CO₂/FC correction for (N)OVC-HEV

Proposed update by ACEA EV for WLTP SG EV to give the option to avoid unnecessary testing without additional value (**updated proposal after 05.03.2020 – revision 2**)

Status: 08.03.2020

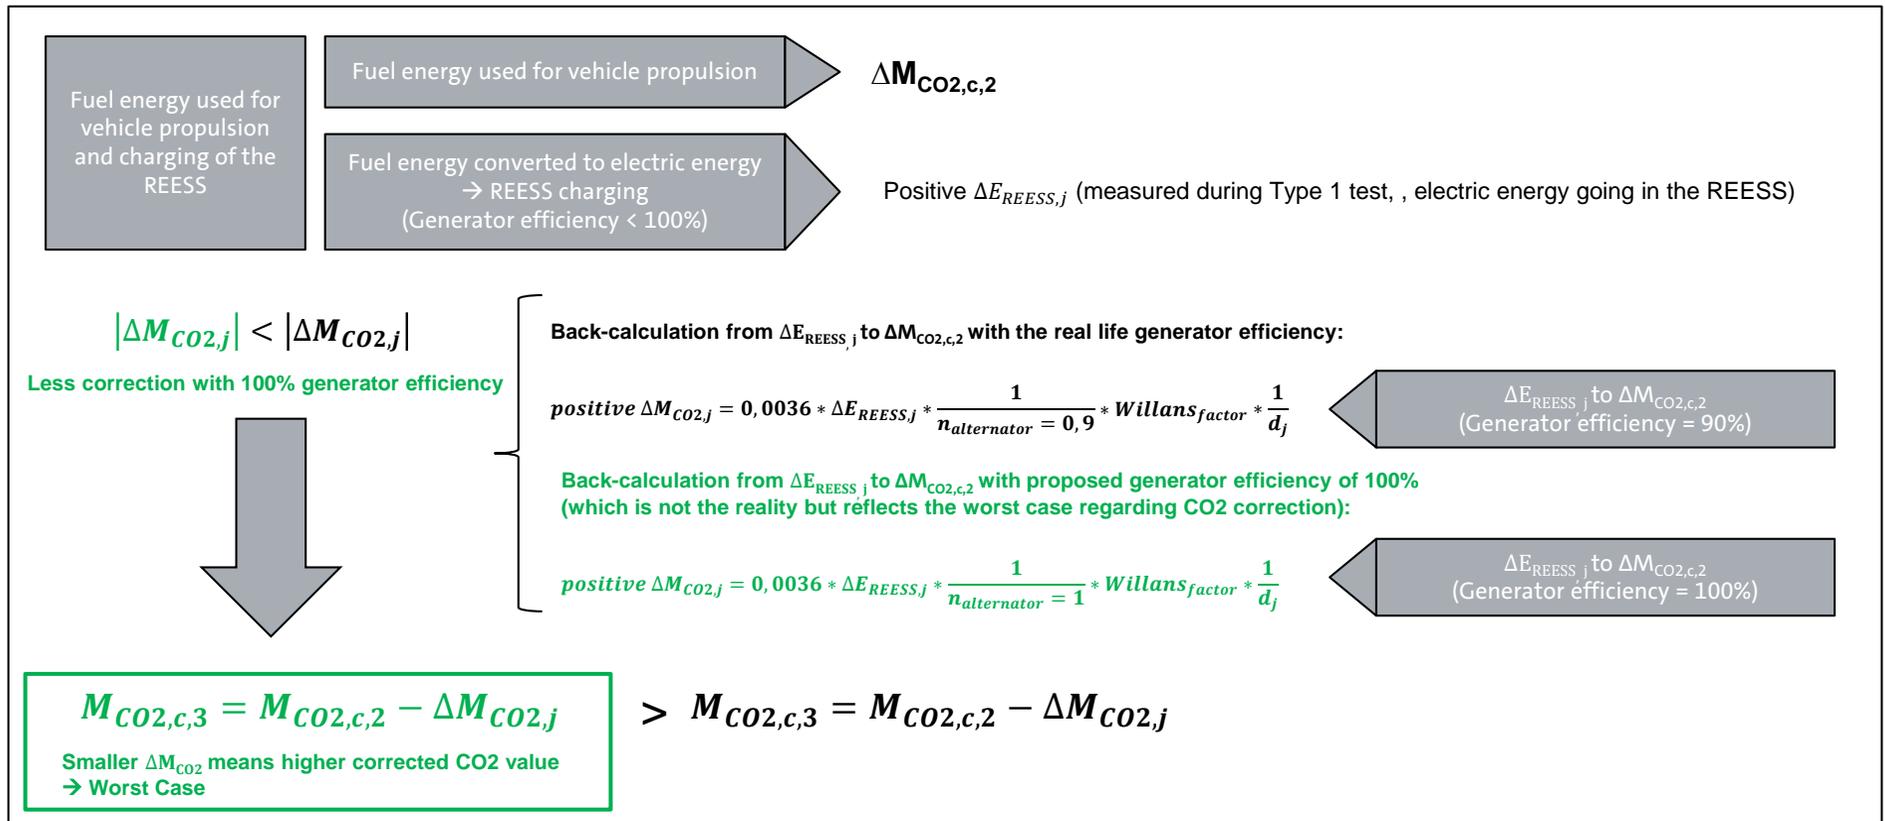
→ In case of charging: With n_{alternator} = 1 → smallest pos. ΔM_{CO₂,j}

→ In case of discharging: With n_{alternator} = 0,67 → higher neg. ΔM_{CO₂,j}
Higher than with real life alternator efficiency

→ With smallest pos. ΔM_{CO₂,j} → highest M_{CO₂,c,3}

→ With higher neg. ΔM_{CO₂,j} → higher M_{CO₂,c,3}
Higher than with real life alternator efficiency

Explanation why assuming a generator efficiency of 67% ($n_{\text{alternator}} = 0,67$) is non beneficial in the context of CO₂/FC correction (discharging)

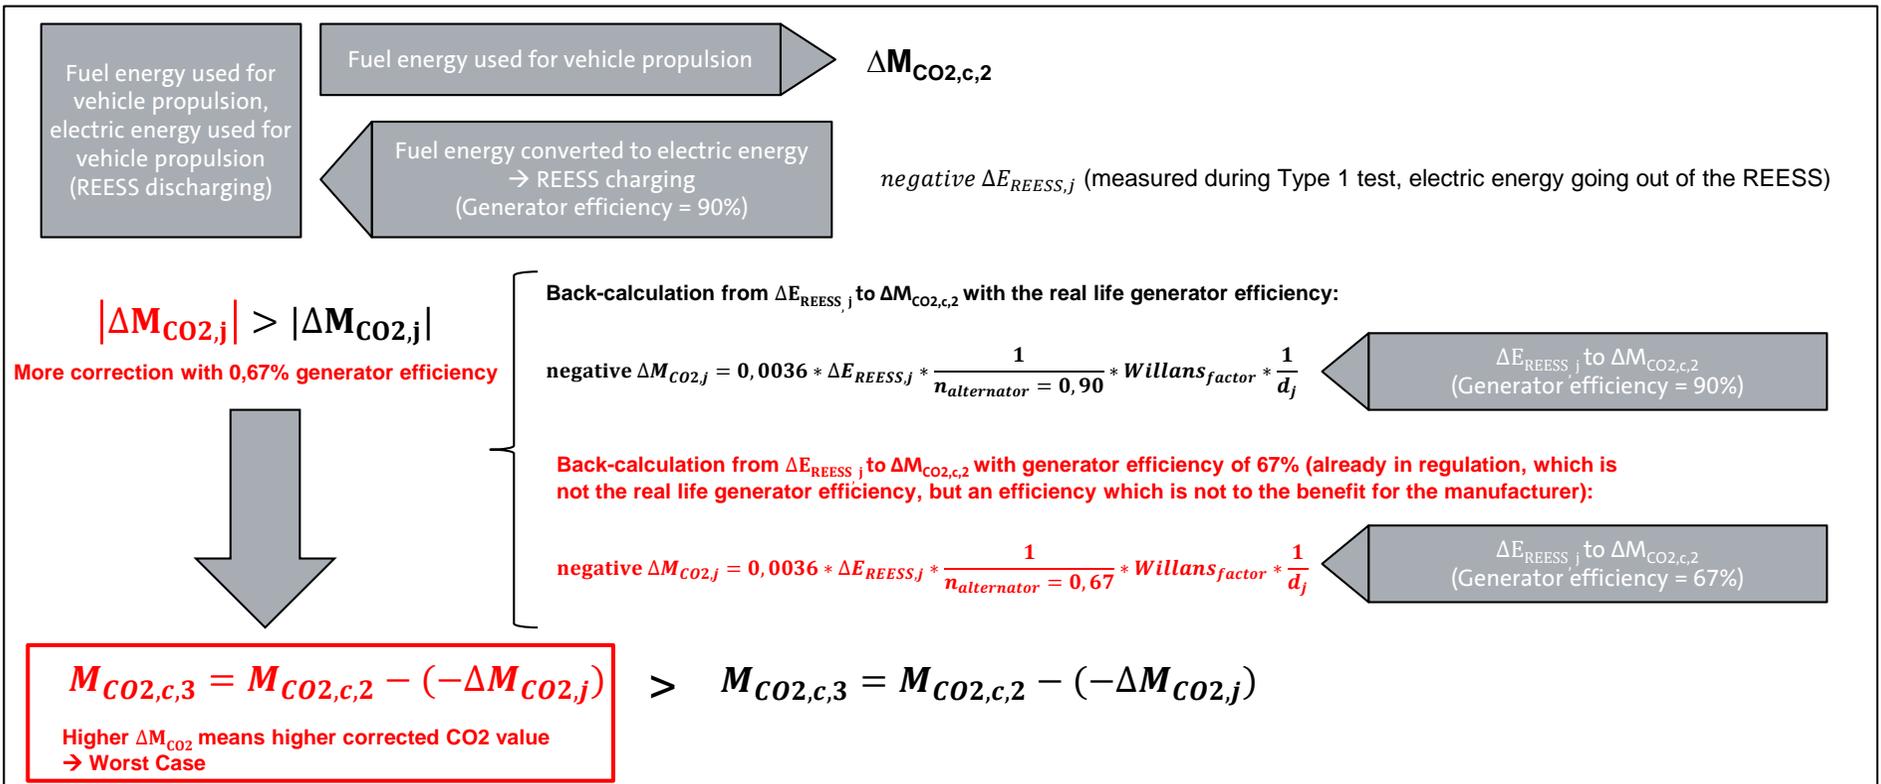
Is the generic approach also the worst case compared to K_{CO_2} derived by measurements?

\rightarrow Yes, because measurements reflect real life and therefore a generator efficiencies of more than 67% but less 100%
